Stage 03: Workgroup Report

GC0099:

Modification Title: Establishing a common approach to interconnector scheduling consistent with the single intraday market coupling processes set out within Regulation (EU) 2015/1222 (CACM).

Figure 1

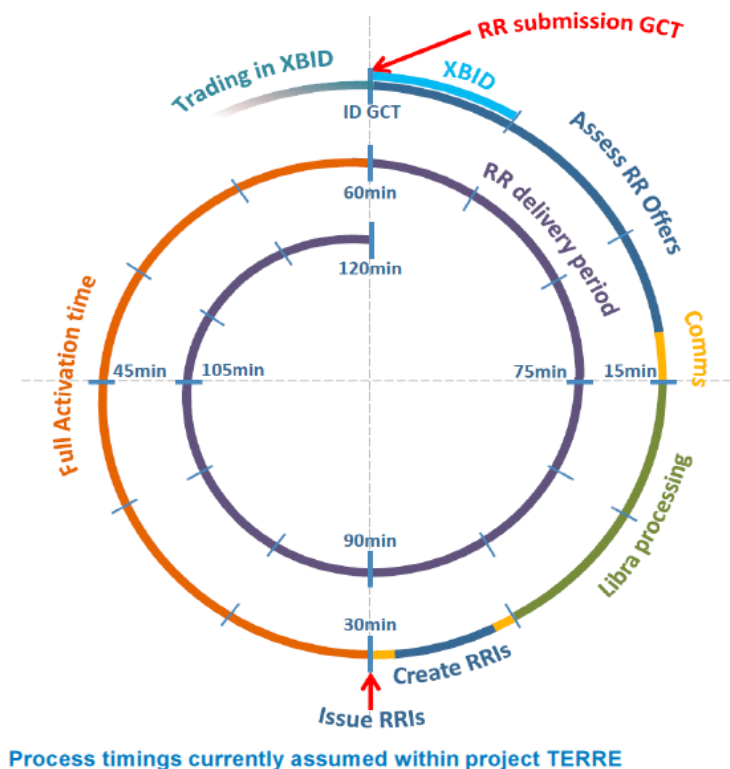
The spiral diagram in figure 1 was talked through; the timings for which reflect the current proposal for the ongoing Modification Project TERRE. The timings being proposed have not all been finalised, however the deadline for receipt of information by the central platform (15 mins after gate closure), full activation time (30 minutes) and the delivery period (60 minutes) have been long established¹ within the TERRE project and National Grid understands that changing these times would represent a significant risk to the successful delivery of the project.
